SIB 61 08 21

CIGARETTE LIGHTER IS DIFFICULT TO PULL OUT

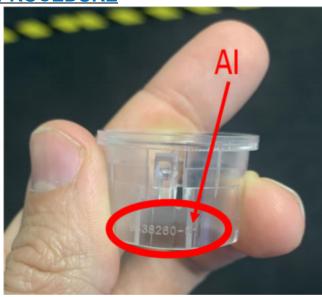
The cigarette lighter is difficult or impossible to pull it out.

Ring light in the center console socket is deformed.

Remove the socket and replace the clamping ring with part number

61 34 9438260 Clamping ring for 12 V power socket.

Note: A clamping ring with the revision index (AI) -02 or higher must be installed.

Alternatively, a ring light with part number 61 42 7947770 Ring light without LED can also be used on vehicles without Ambient Lighting.
